# PLANNING COMMISSION
## MEETING AGENDA
### REGULAR MEETING

8. SPECIAL USE REQUEST AND PRELIMINARY SITE PLAN REVIEW (File Number SU JPLN2016-0005) – Proposed K-9 Club, North side of Maple, West of Rochester between Eastport and Westwood, Section 27, Currently Zoned MR (Maple Road) District

SUBJECT: SPECIAL USE REQUEST AND PRELIMINARY SITE PLAN REVIEW (File Number SU JPLN2016-0005) – Proposed K-9 Club, North side of Maple, West of Rochester between Eastport and Westwood, Section 27, Currently Zoned MR (Maple Road) District

# Preliminary Site Plan and Special Use Review
# For
# City of Troy, Michigan

## SITE PLAN

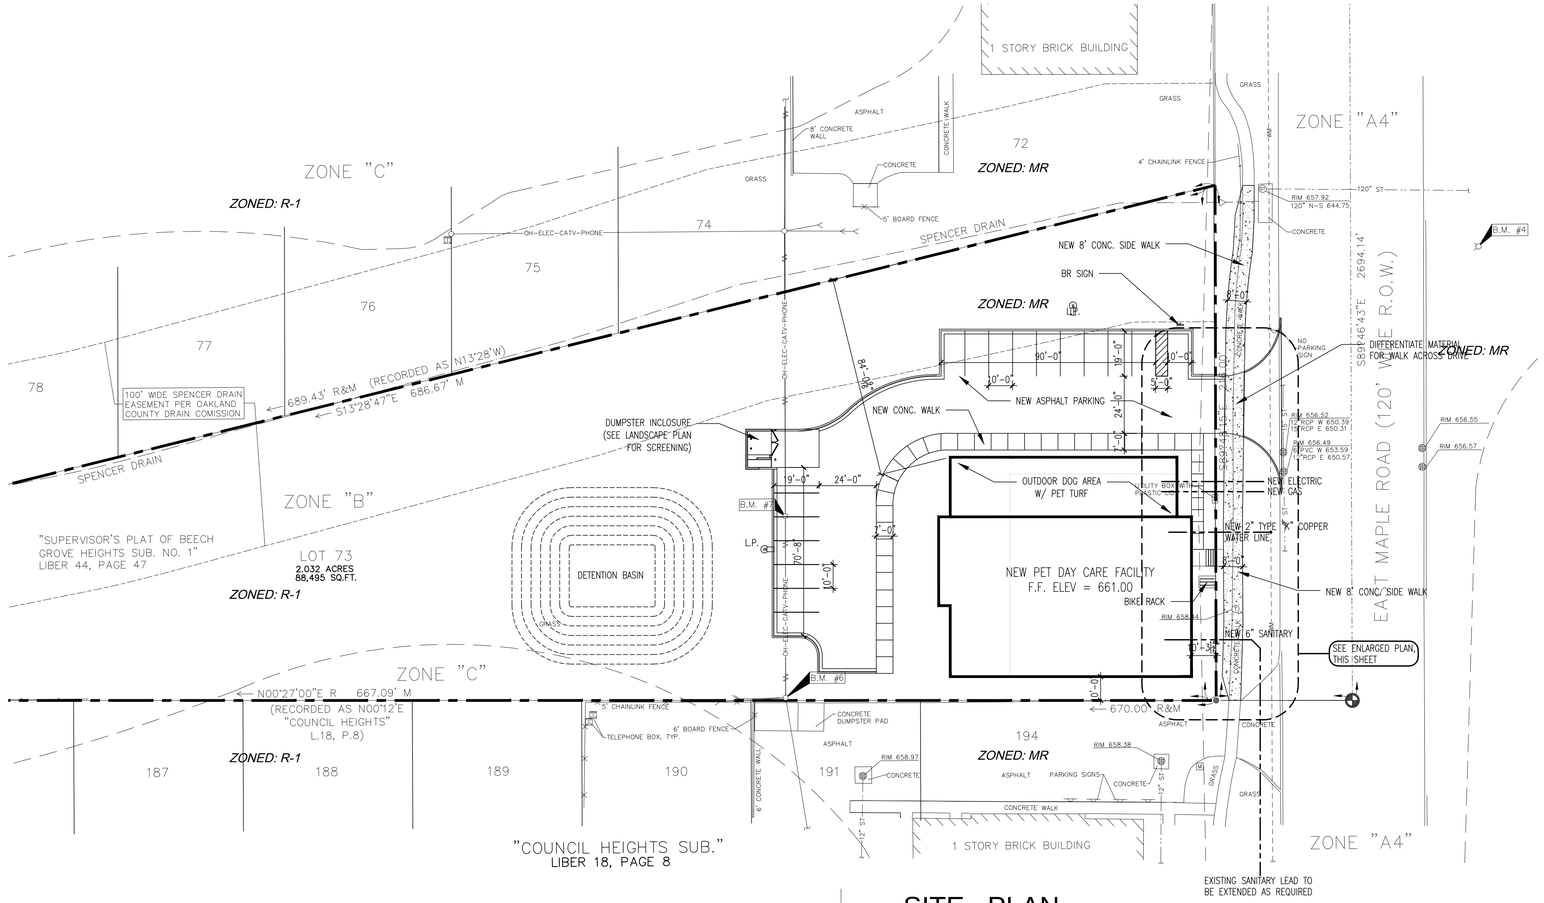
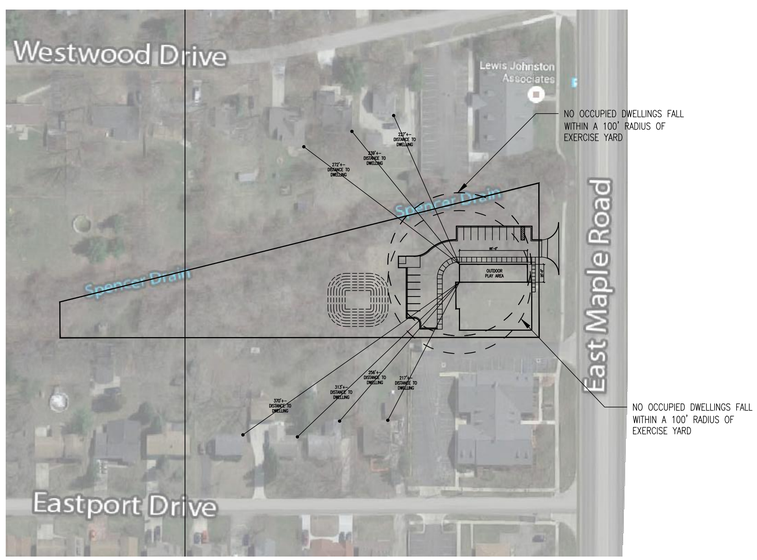
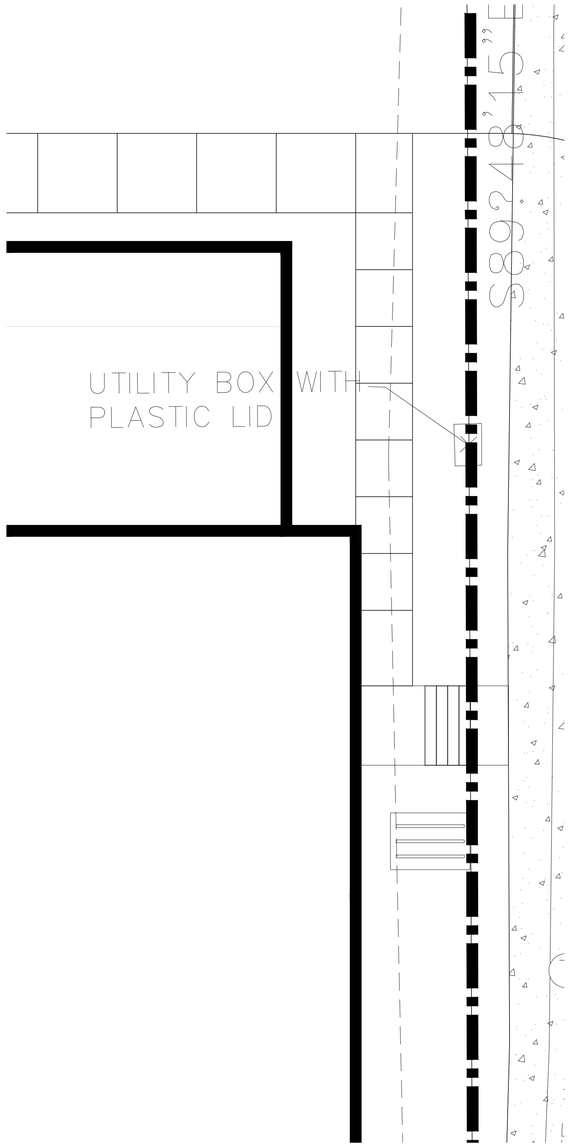
The building, parking lot, and outdoor play area is adjacent to office uses to the west and east. The remaining portions of the parcel that are adjacent to single-family residential is proposed to remain undeveloped. Discussed in more detail in the body of this memo, the applicant has attempted to mitigate impacts of the noise and odor of the operation.

The applicant has amended the site plan based on neighborhood and Planning Commission feedback.

## CHANGES SINCE LAST PLANNING COMMISSION CONSIDERATION

At the March 8, 2106 meeting the Planning Commission continued the matter to allow the applicant to make changes to the site plan to address concerns over potential impact to adjacent properties.

The applicant notes that they are going to hire an acoustical engineering company to create a predictive model to ensure the new dog outdoor exercise meets the Troy requirement of less than 65 decibels at the property line. The applicant has included a revised narrative to discuss attempts to address noise concerns.

The relocaction of the outdoor exercise area, along with size and wall modifications, will reduce K9 Club noise levels at the property lines to within the Troy zoning ordinance requirements.
